Minutes of meeting: Radiation Safety Committee

Date: Tuesday 22 November 1994

Subject(s): 1. Integrating NMC's - A.Stillman  
2. C1 Beamstop - A.Carroll  
3. FEB zero degree port.  
Review of OPM section 9.1.\* procedures.

3. FEB zero degree port.

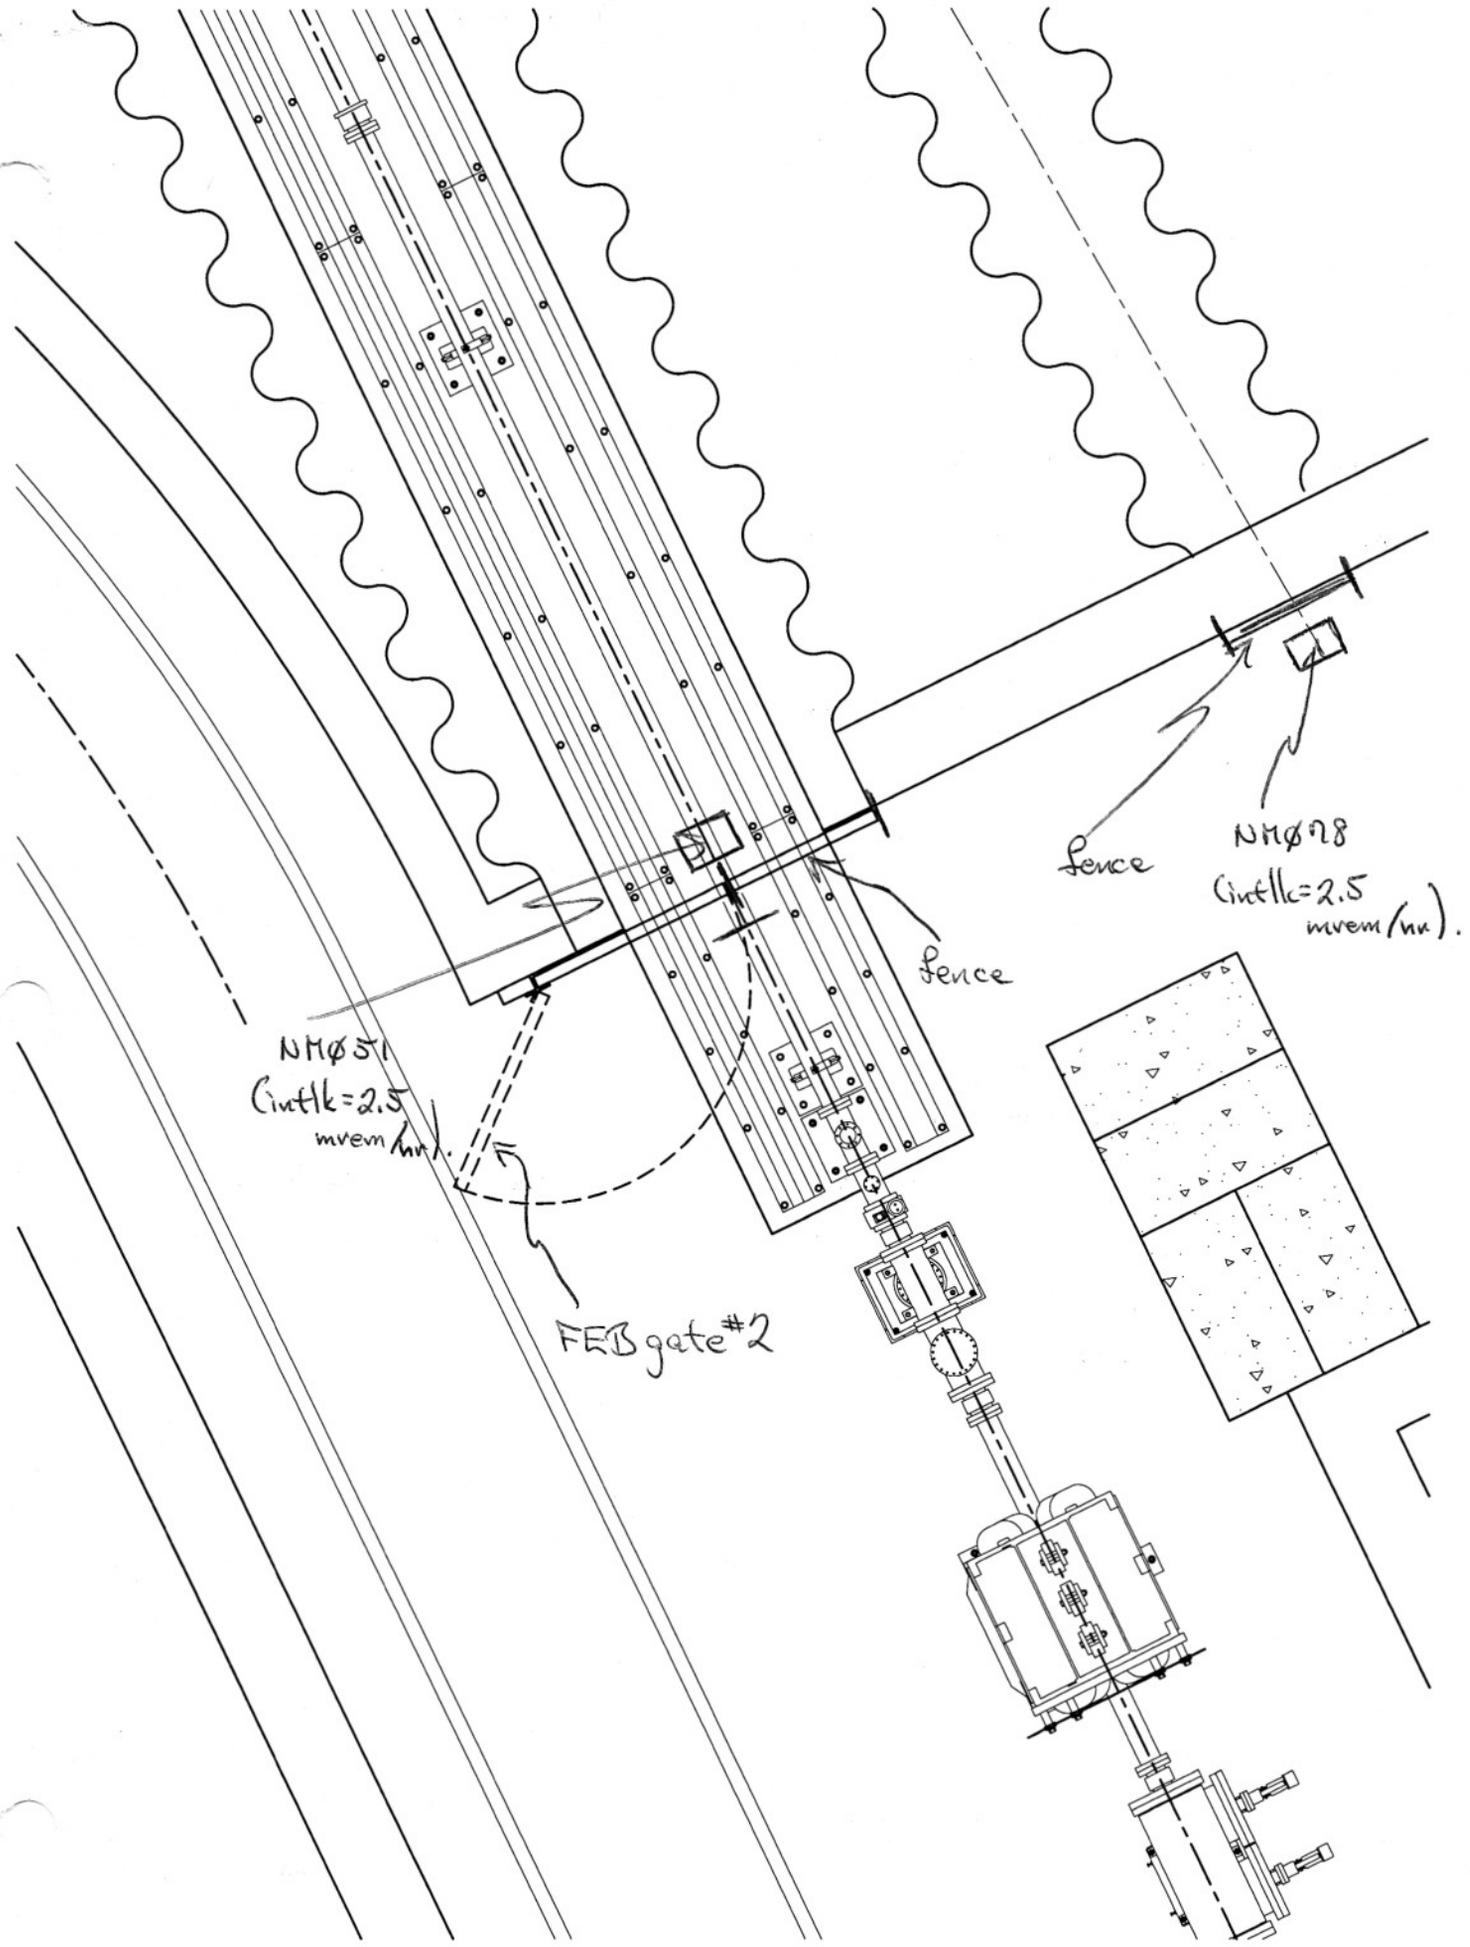
A request was made to allow access to the area immediately downstream of the FEB zero degree port during this FY95 operating period. The port will be fenced (drawing attached) and an interlocking chipmunk (NMO78) will be placed at the exit of this port (intlk = 2.5mrem/hr). The U-line FEB port has an interlocking chipmunk (NMO51, intlk = 2.5mrem/hr) and these should be sensitive to the same loss mechanism. The committee made the following recommendations;

1. The permanent fences at these ports have "security wire" threaded through to provide an interlock should anyone try to open the fence.
2. The fences should represent a "credible barrier".
